**BASIC COMMERCIAL DESIGN CRITERIA**

Project Name/No. **Market Flats**

☒ Concept Design Review

☒ Detail Design Review

Complies ☒ Conflicts ☒ N/A ☐  
South Elevation

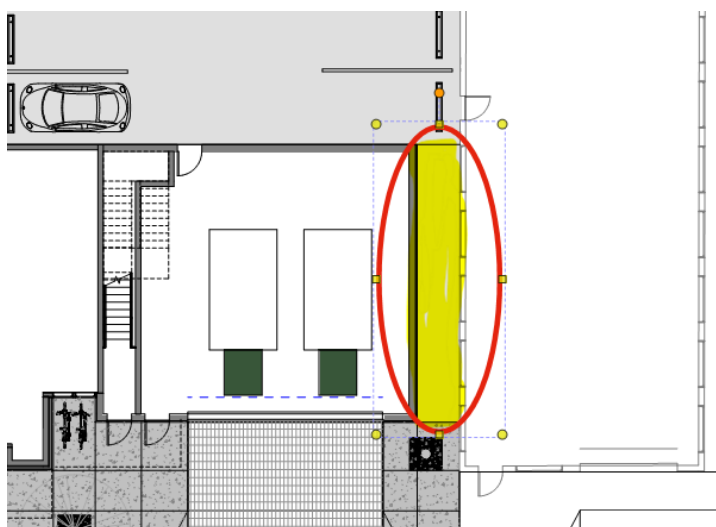
**STAFF RESPONSE:** The main exterior material of the building facade facing Capitol Way (West facade) is all brick whereas the exterior materials used on the north and south facades is a mix of brick, metal cladding and a hint of use of a hardi panel system. The east facade is mainly the hardi panel system and metal cladding with a hint of brick. Staff believes that the project does not have a consistent visual identity of the east and west facades.

**STAFF RESPONSE:** The exterior of the building is made of mainly brick on the façade facing Capitol Way, and a mix of brick and metal cladding on the Olympia Avenue façade. The south façade is a mix of dark bronze metal cladding with the vast majority of the façade done in hardi panel in a light beige to off white color.
